Instream Flow Study of the Lower San Antonio River and Lower Cibolo Creek

Study Design

Prepared by
***TEXAS INSTREAM FLOW PROGRAM
AND SAN ANTONIO RIVER AUTHORITY***

MARCH 2012

Figure 1. Map of the San Antonio River basin and lower San Antonio River sub-basin (study boundary) depicted.

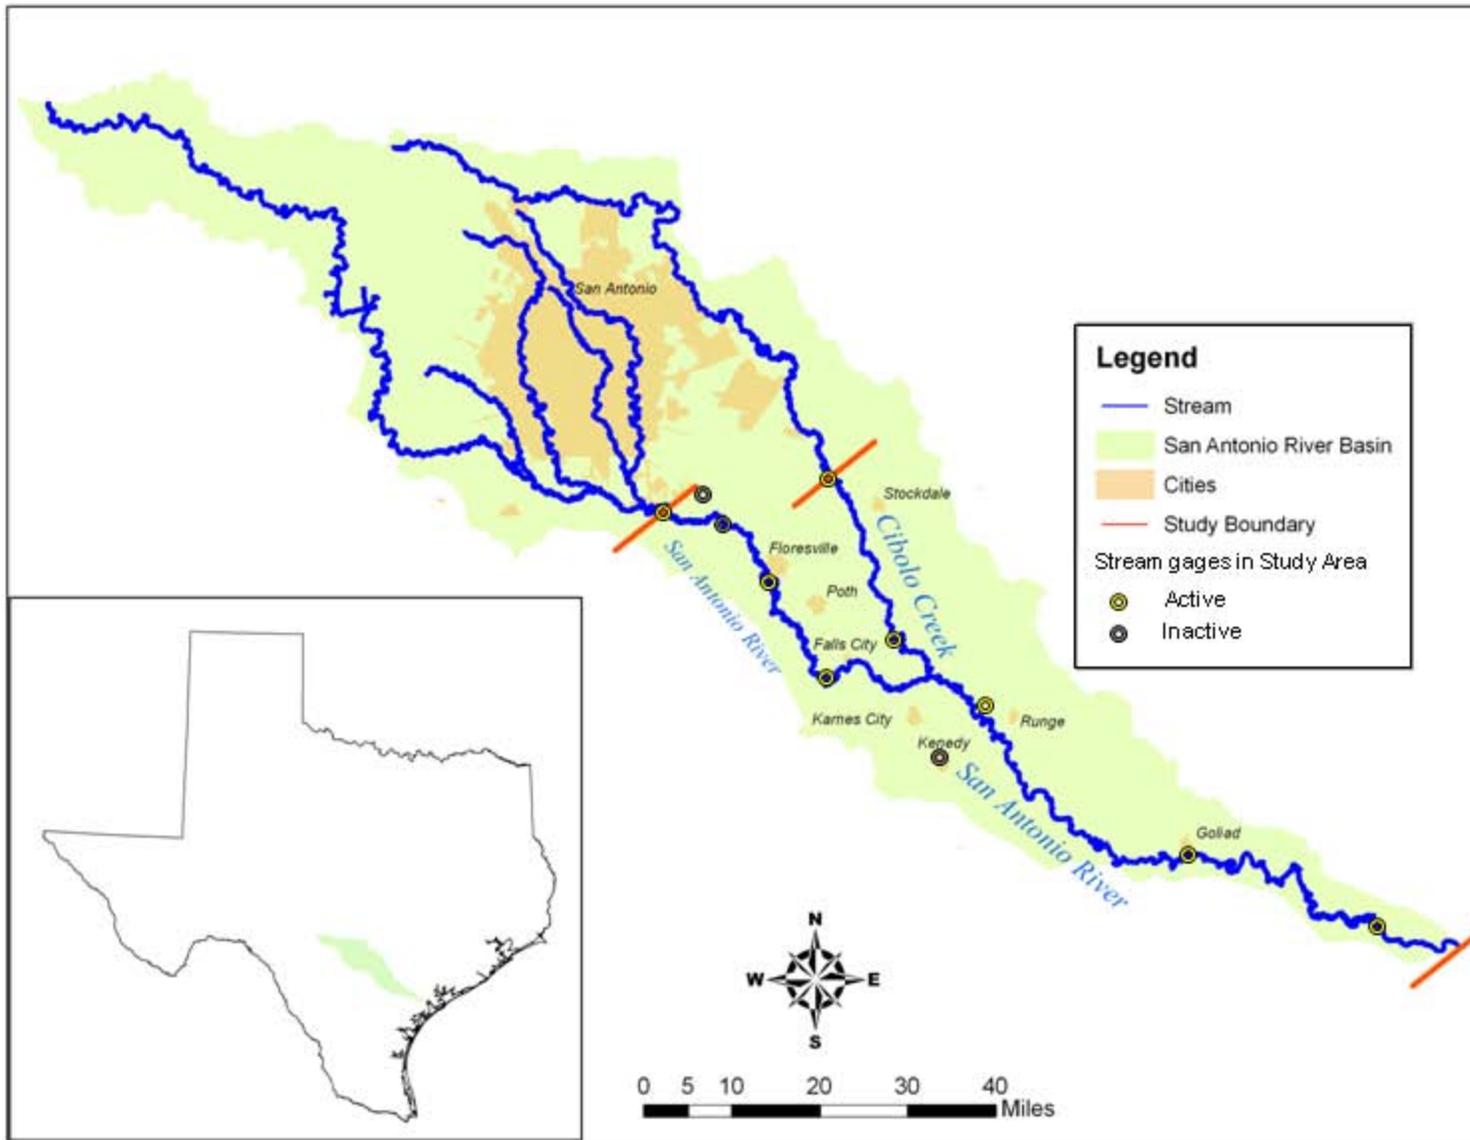
Comment 3 - Page 5, Table 2. It is not possible to determine the location of these gages from the information provided. A figure showing location is necessary. These locations could be added to Figure 1. The Table should also show the number of complete years of record for each gage.

Response 3 - Gage locations have been added to Figure 1. The number of years of record can be inferred from the “Earliest” and “Latest Record” columns in Table 2.

Figure 3. Flow duration curves for daily average flow at USGS gage 08188500, San Antonio River at Goliad.

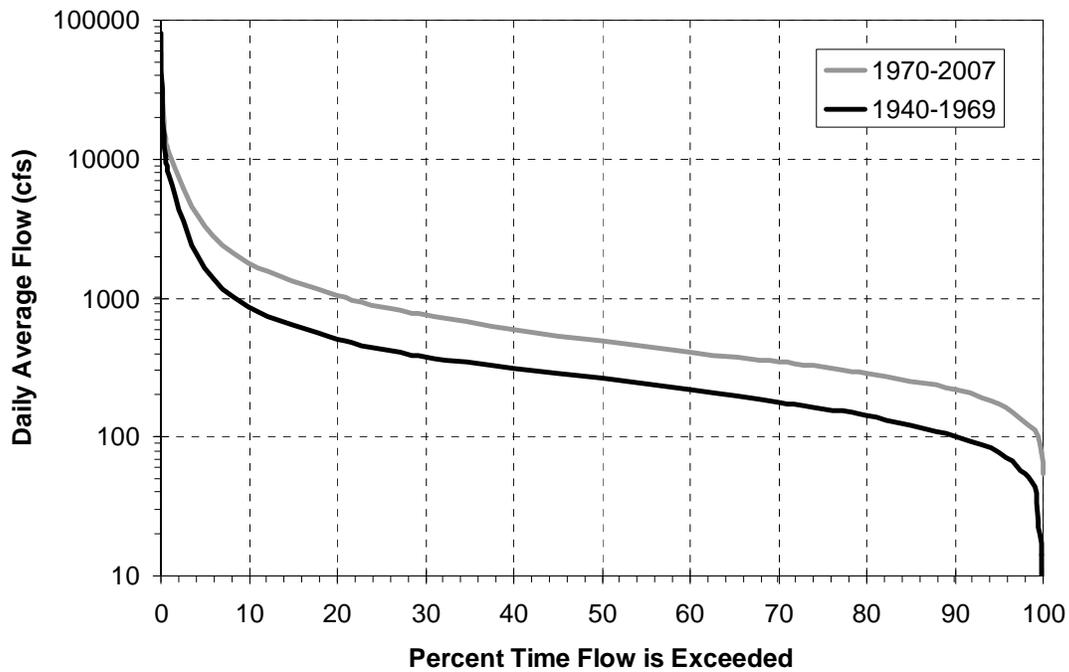
Comment 1 - The degree to which flows in the lower San Antonio River changed before and after 1970 is somewhat misleading by the data and information presented in the report. For example, the two curves plotted in Figure 2 and in Figure 3 do not represent an equal number of years of flow data (38 versus 30), with almost a third of the shorter pre-1970 period encompassing the 1950s drought of record. Based solely on these facts, it is not surprising that the pre-1970 flows are substantially lower than the post-1970 flows, particularly when the report clearly acknowledges with the bar chart in Figure 4 that there was significantly less rainfall during this earlier period than the latter period. What needs to be presented are the data that truly substantiate why there is more base flow in the lower San Antonio River now than in the past, that is, the historical wastewater return flow data. This would clearly make the point. If a river flow plot is to be used for this purpose, then it has to be based on historical flow data for periods of equal duration and very similar rainfall conditions; otherwise, the flow changes due to varying climatic conditions overshadow the effects of the increased wastewater return flows or whatever else (i.e., increased impervious cover in San Antonio) may have impacted historical flows along the lower San Antonio River.

Response 1 - The information in Section 1.1.1 and Figures 2, 3, and 4 is presented to insure readers (stakeholders or scientific peer reviewers) are familiar with some of the hydrologic considerations related to the lower San Antonio River sub-basin. The main point is that “flow conditions in the lower San Antonio River sub-basin have been changing over time.” The information is presented as an example of the degree of hydrologic change in the basin, not an attempt to determine the causes of that change. As part of the study, a hydrologic evaluation of changes in the sub-basin will be conducted (please see Section 3.2.1 of the Study Design).

Figure 4. Average monthly precipitation for San Antonio, Texas for the periods 1940 to 1969 and 1970 to 2007 (National Weather Service data).

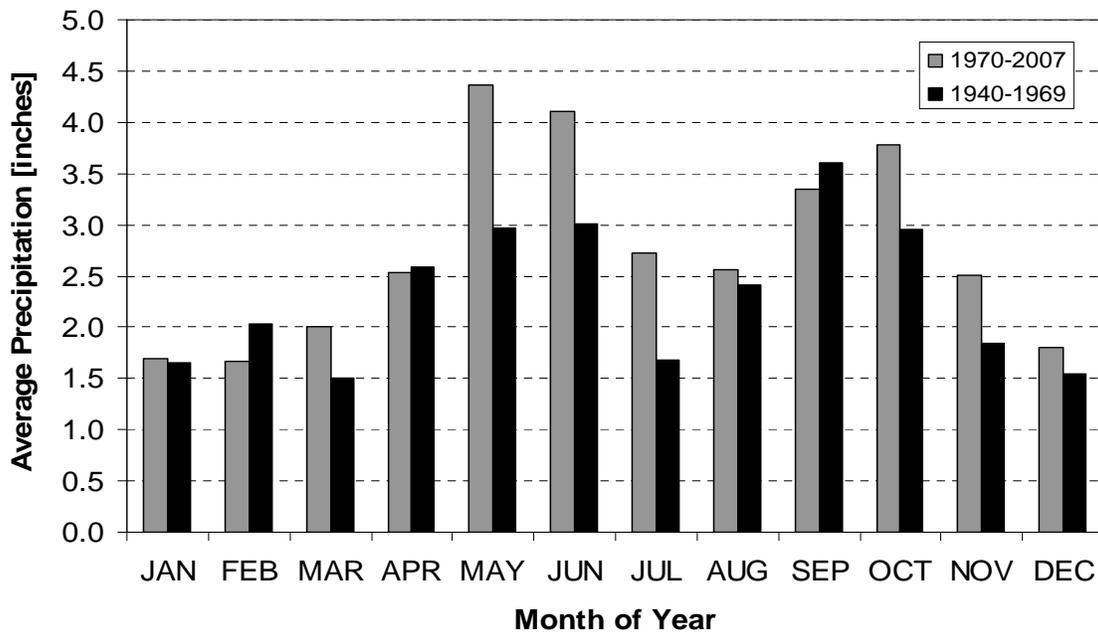
Comment 7 - Page 8, Figure 4. What is the change in total annual precipitation since 1970? The difference on the graph appears small.

Figure 9. General conceptual model of the riverine ecosystem, lower San Antonio River sub-basin.

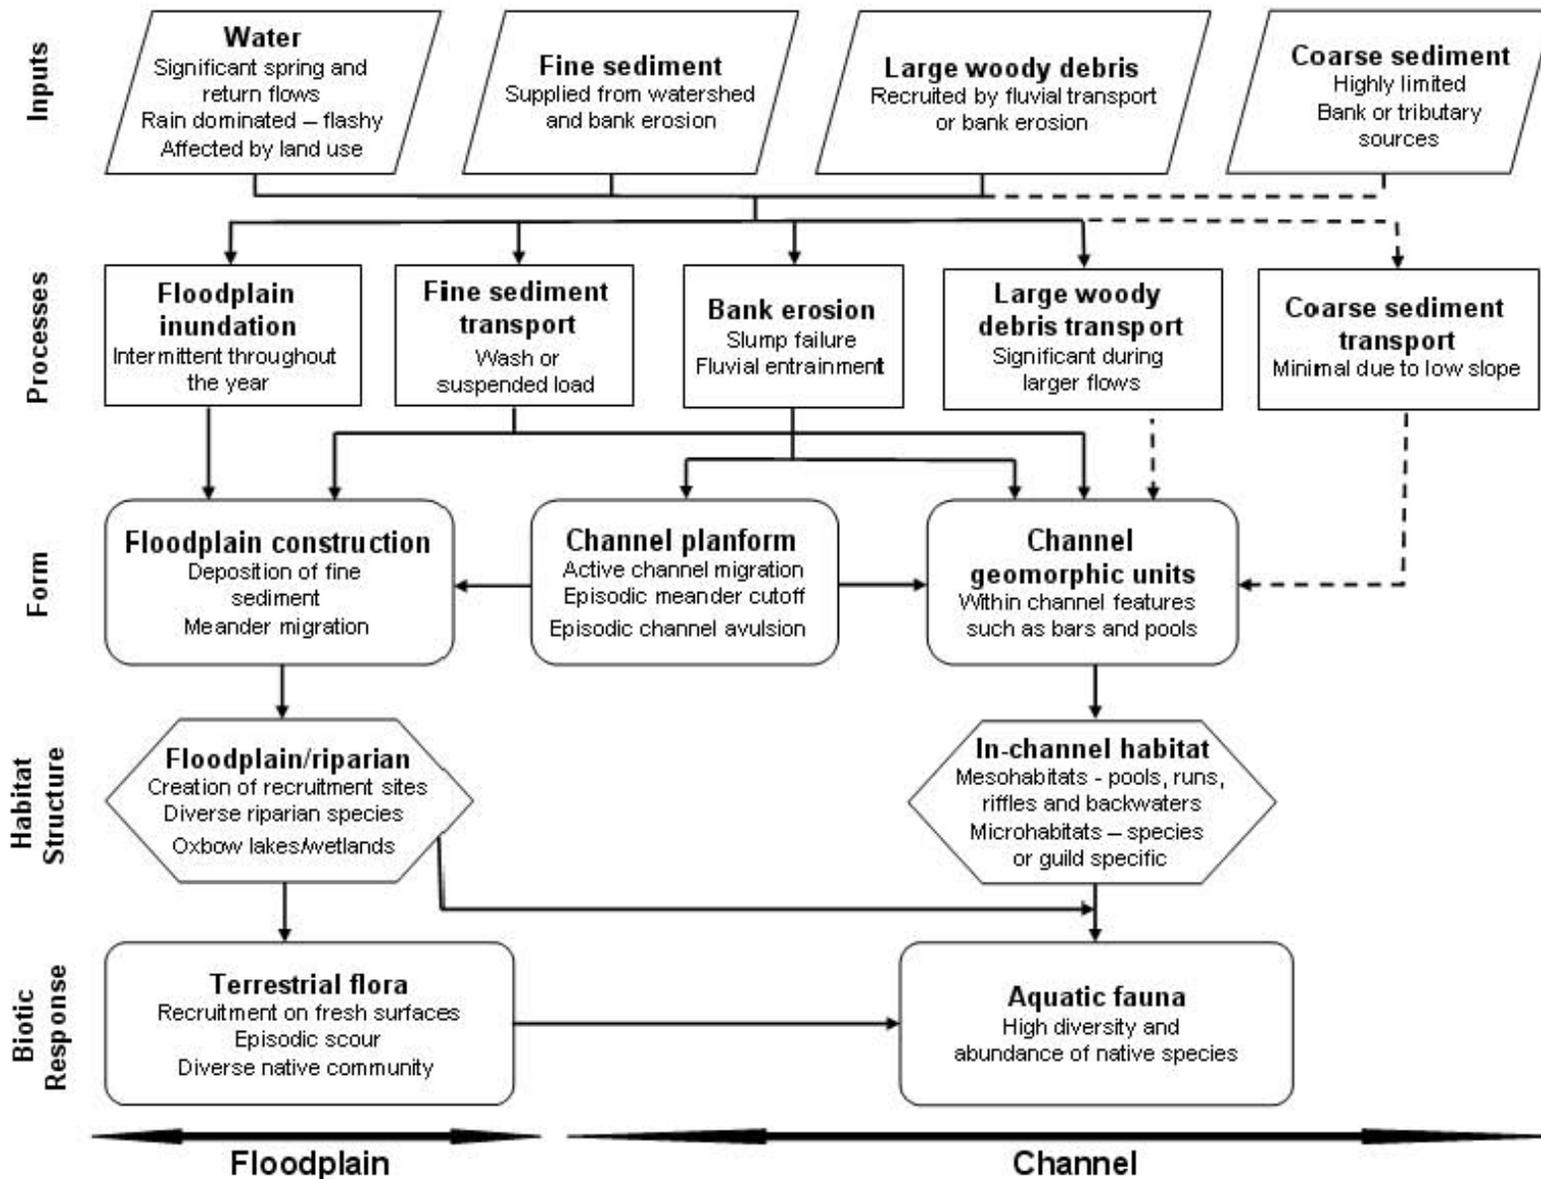
Comment 6 - It is not clear as to exactly what the Conceptual Model described in Section 1.3 and depicted in Figure 10 (*Ed. changed to Figure 9*) is supposed to represent. Is it the riverine ecosystem? The diagram seems to be missing some important elements, such as wastewater return flows that are discharged into the San Antonio River under Inputs, a water quality function linked to other components of the ecosystem, and riparian habitat and connectivity with the stream channel. It is not clear how this representation "incorporates much of the basic understanding of the system at the point of study initiation" or "represents a beginning point from which to develop flow/ecology relationships and direct studies to further refine understanding".

Comment 39 - Figure 10 (*Ed. changed to Figure 9*) on page 26 shows a graphic representation of the conceptual model for the San Antonio Basin study. In the biotic response row aquatic flora is omitted. The draft study design discusses determining critical habitat for aquatic fauna at the defined flow regimes. Aquatic habitats consists of many and dynamic elements. Aquatic flora, in many aquatic systems, is both a diverse biotic community and a vital element of habitat for aquatic fauna. Staff should add aquatic flora to the list of biotic communities studied.

Response 6 - The caption has been modified to more directly specify that the figure refers to the riverine ecosystem of the sub-basin. The contribution of return flows to water input to the system has also been noted in the Inputs/Water portion of the figure. Potential linkages between water quality and flow regime components are shown in Table 6. These linkages will be the focus of TIFP studies. Possible linkages between ecosystem components and water quality can be inferred from Figure 9. For example, healthy floodplain/riparian habitats may provide suitable stream temperature conditions (due to shading), exerting a positive impact on the suitability of in-channel habitat for aquatic fauna. However, these interactions are not as directly related to flow and therefore, are not slated to be investigated as part of this study. If these interactions are found to be significant, they could be addressed by future studies. "Floodplain/riparian" habitats are a specific component in Figure 9. Connectivity between floodplain and channel processes, forms, habitats, and biota are also shown in the figure.

Figure 10. Map of Tier 1 Study Segments, regional geology (Brown et al. 2000) and valley edge (Engel and Curran 2008).

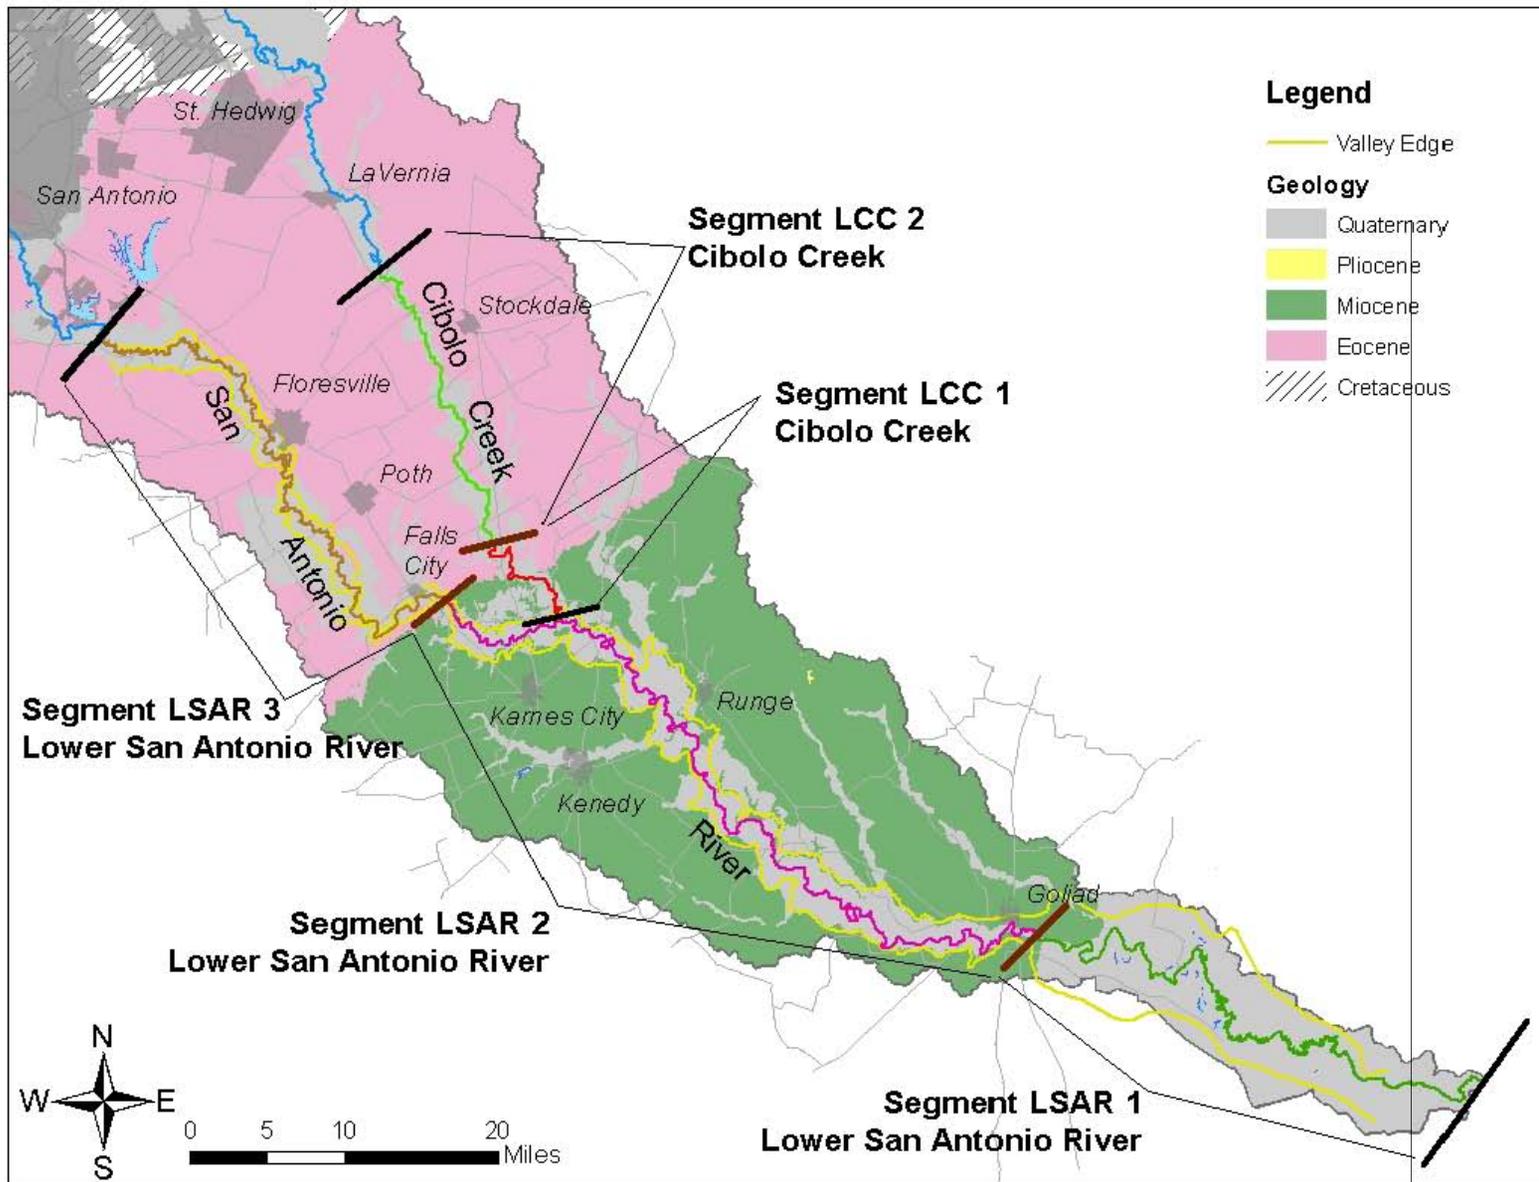
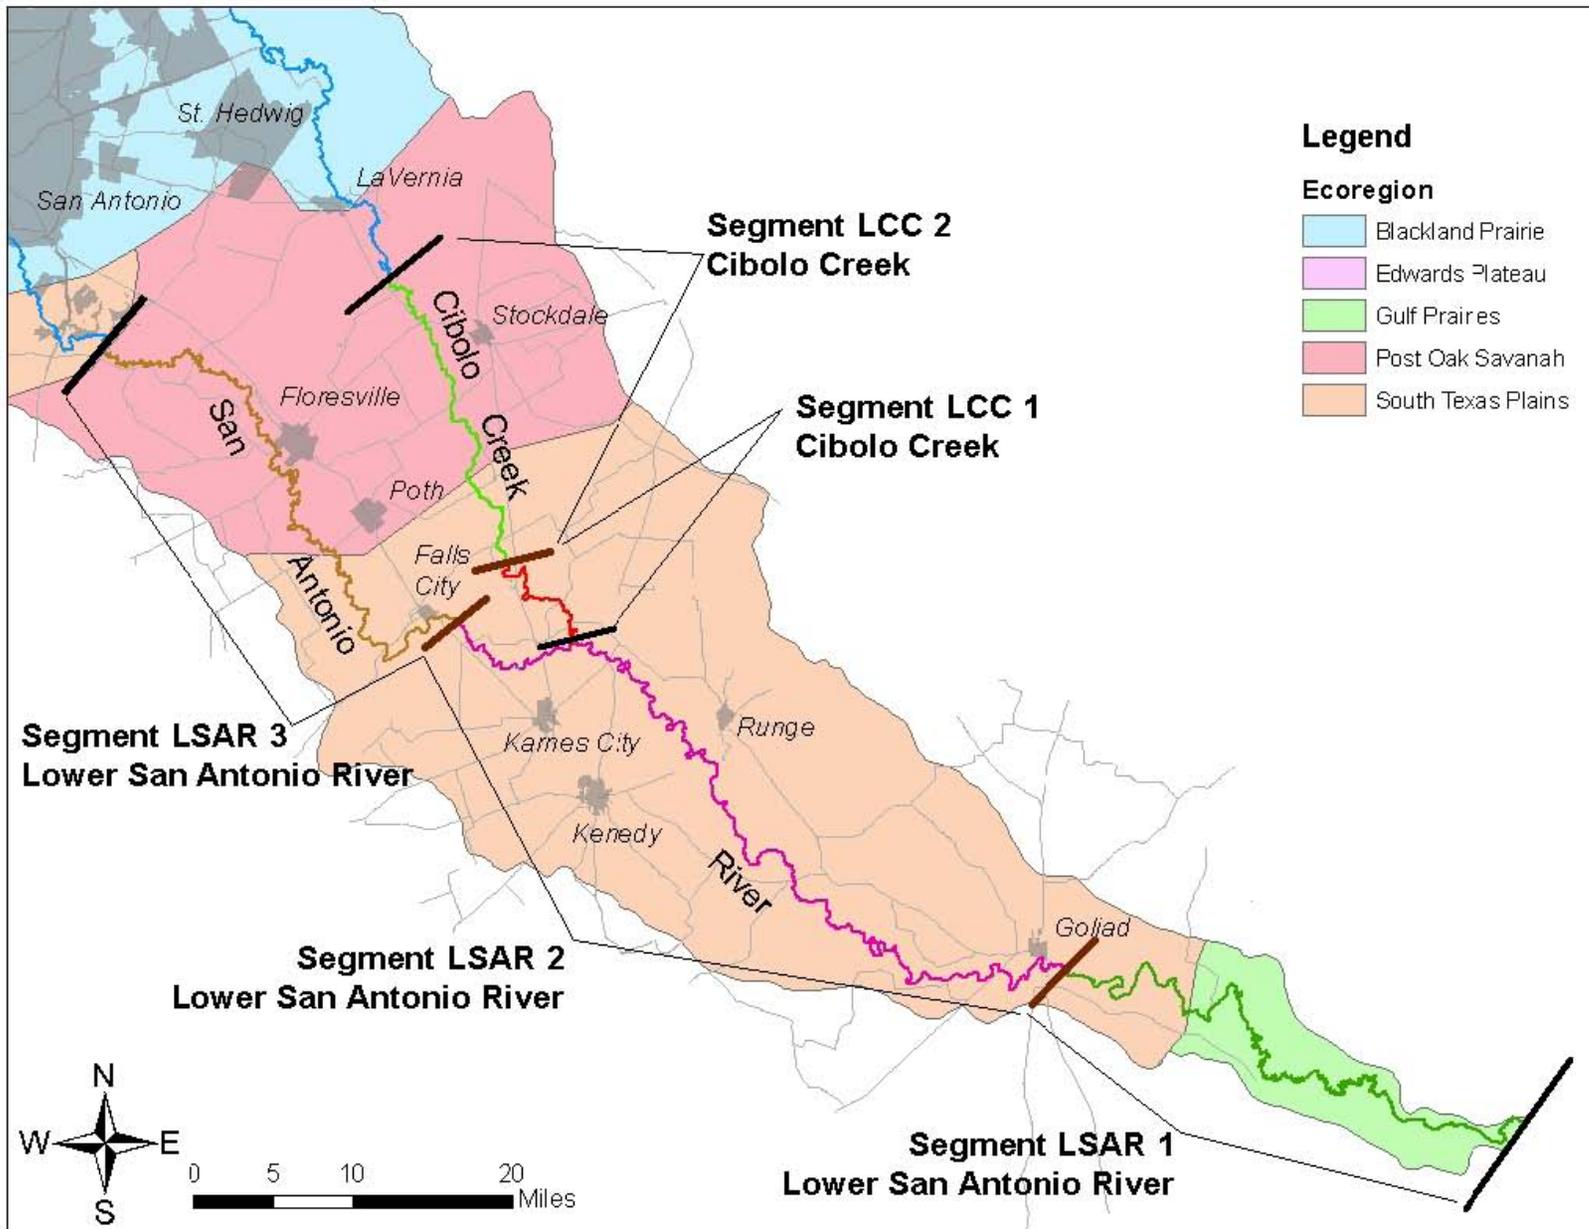
Comment 12 - Looking at the maps of regional geology in Figure 11 (*Ed. changed to Figure 10*) and ecoregions in Figure 12 (*Ed. changed to Figure 11*), it appears that only the regional geology was considered when delineating Tier 1 study segments, even though at the bottom of page 38 both are indicated to have been examined.

Response 12 - As stated in the Study Design, “geological properties, valley shape, and Texas Ecoregions” were used to delineate Tier 1 Study Segments. Each of these criteria were considered during the selection of Study Reaches, keeping in mind that both the regional geology (shown in Figure 10) and ecoregions (shown in Figure 11) represent overall conditions across a large extent of area, not necessarily precisely at the stream channel.
